XII STONES INC.

ADDENDUM 1

Project: Wayne Maintenance Facility Roof Replacement
District 3
NDOR Building Number: 33702
Project: AFE I-302

SHEET
D-1
 Number 1 of 4

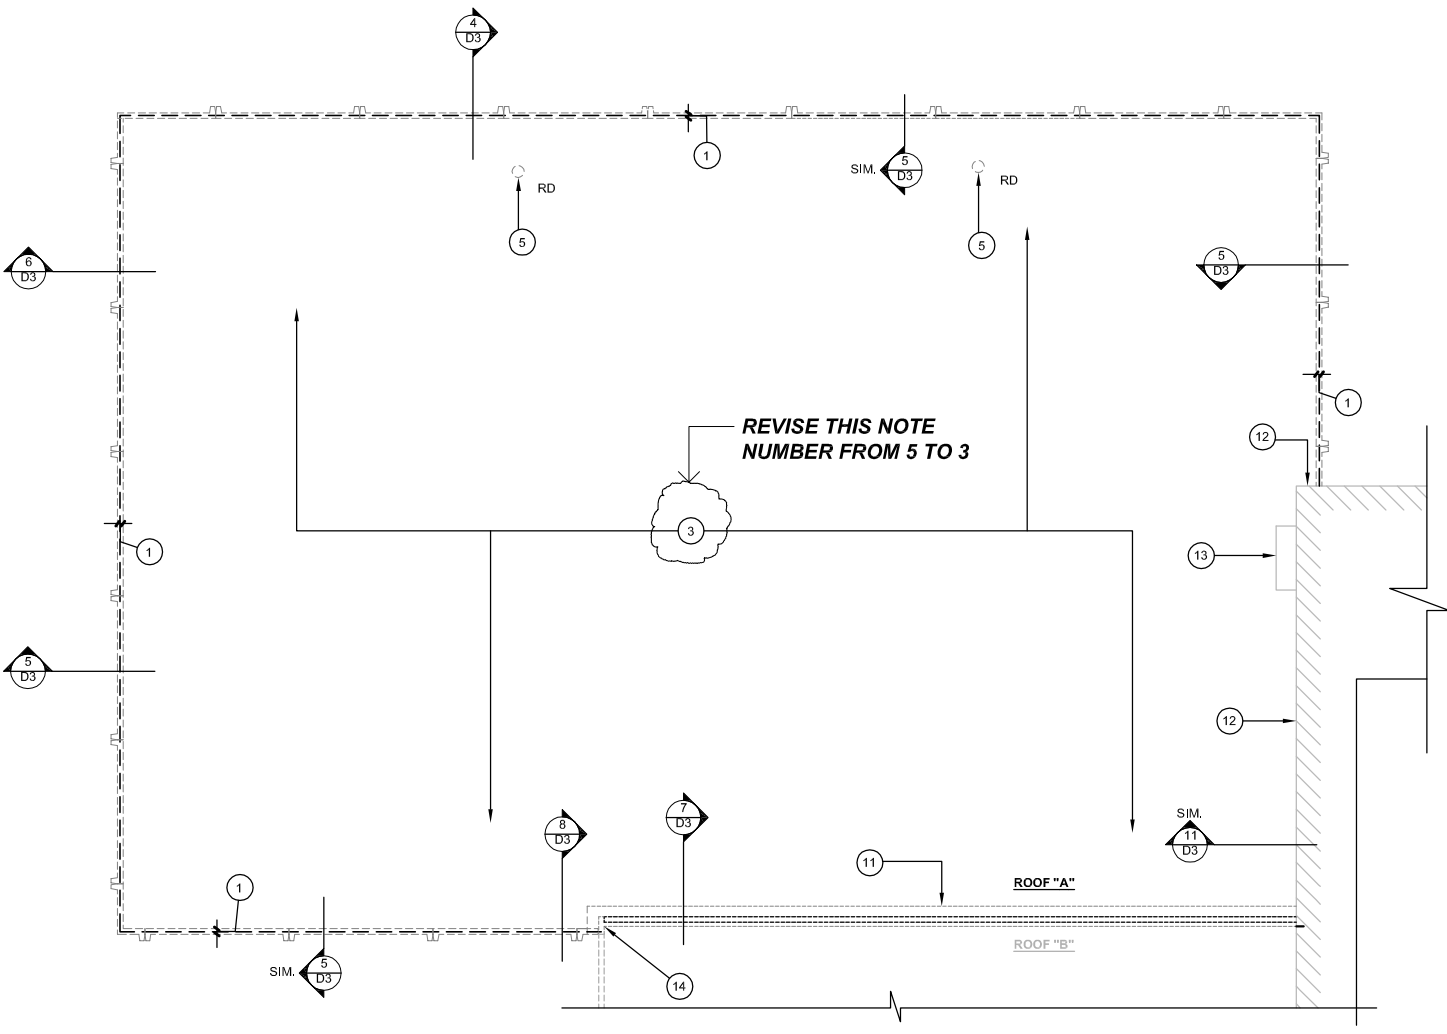
1. Sheet D-1, Roof Plan "A", Note #5
 - A. Change Note Number 5 to Note Number 3 as shown on sheet number 1 of 4 of the attached addendum drawings.

REVISED NOTE NUMBER ON ROOF PLAN 'A'

SHEET
D-3
Number 2 of 4

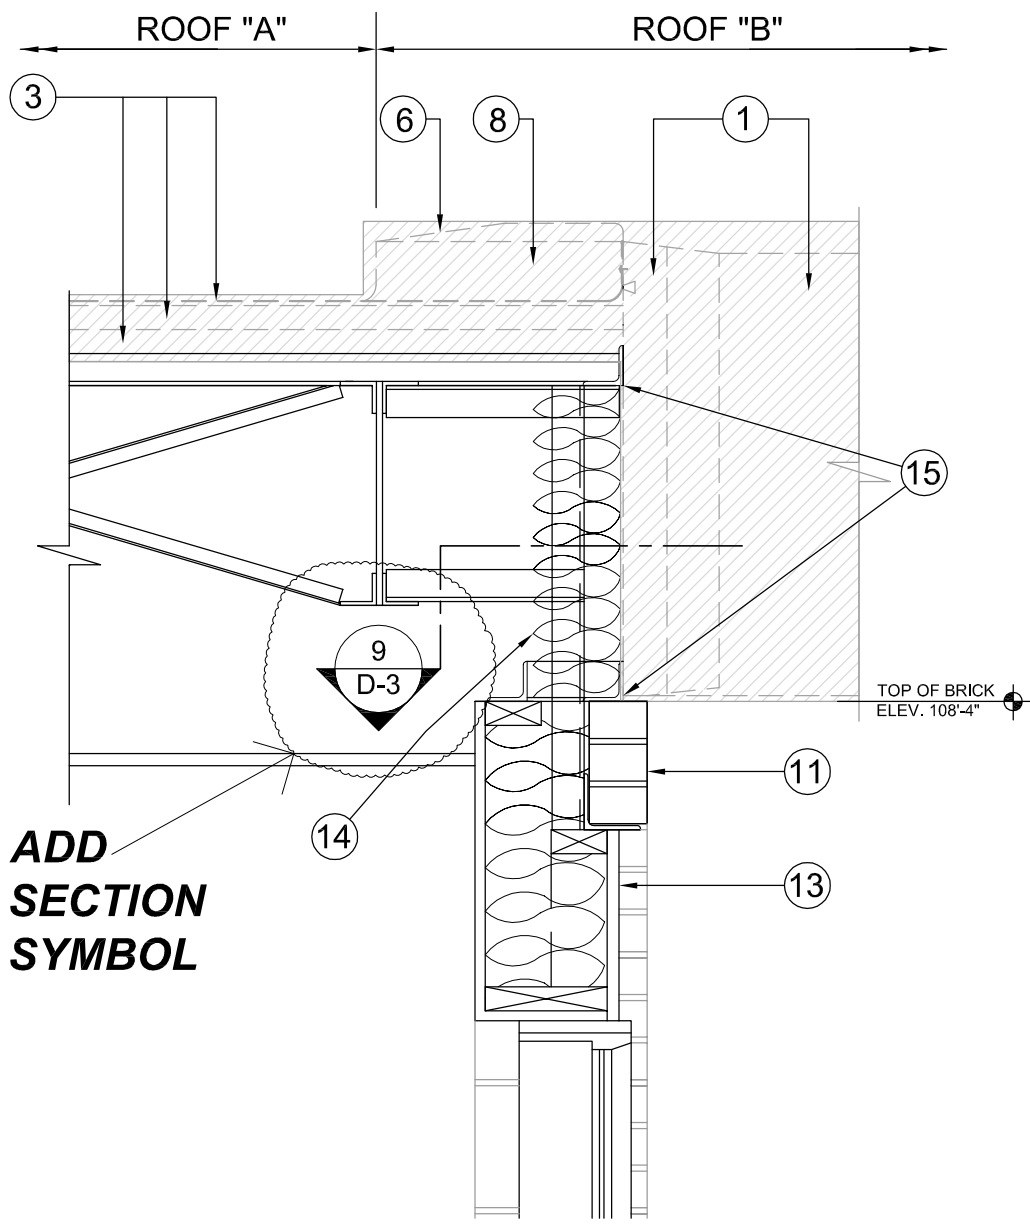
2. Sheet D-3
 - A. Add section symbol in detail 8/D3 as shown in on sheet number 2 of 4 of the attached addendum drawings.
 - B. Remove Note Number 15 in its entirety and replace it with the following: "Protect and retain the existing support structure as much as possible and coordinate all new structural components with existing structure. See Structural Sheet S-1.

7
A5 **DETAIL @ LOW TO UPPER ROOF**
3" = 1' - 0"

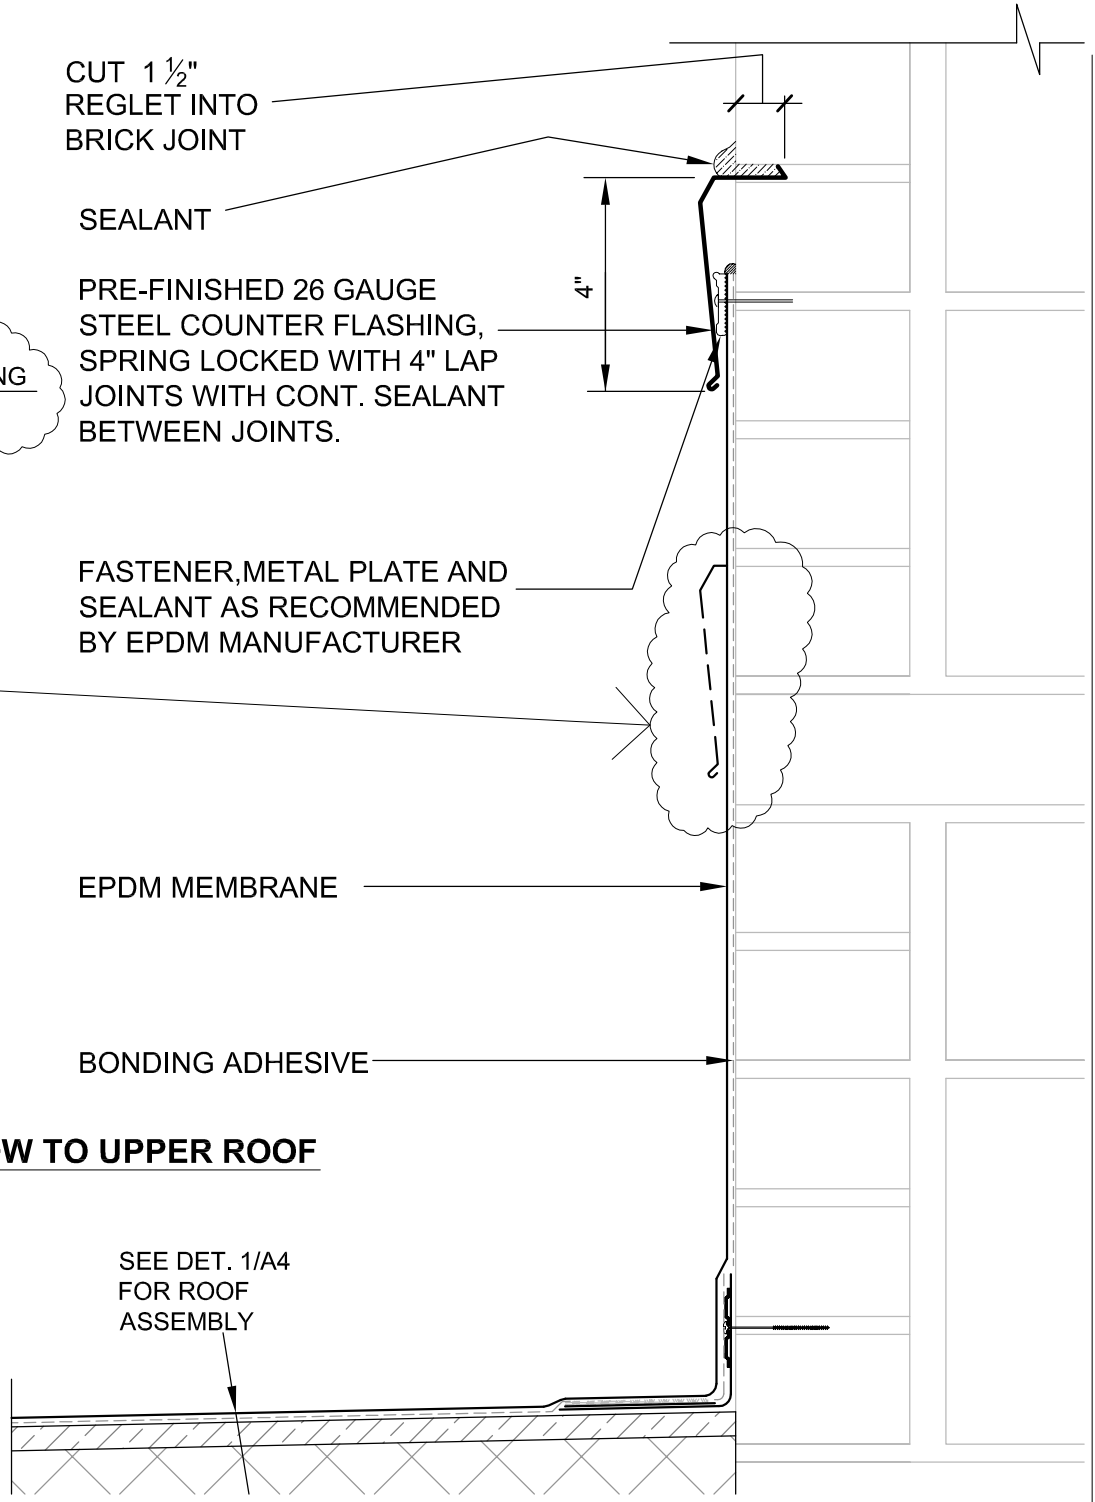
3. Sheet A-5, Detail 7/A5
 - A. Bottom of counter flashing, at wall of Roof "C", shall be at elevation 113'-0" as shown on sheet number 4 of 4 of the attached addendum drawings.
 - B. Counter flashing, at wall of Roof "C", shall step down at metal exhaust hood at west end of wall. See sheet number 4 of 4 on the attached addendum drawings.

B.O. COUNTER FLASHING SHALL BE ELEV. 113'-0"

STEP COUNTER FLASHING AT EXISTING METAL HOOD BEYOND
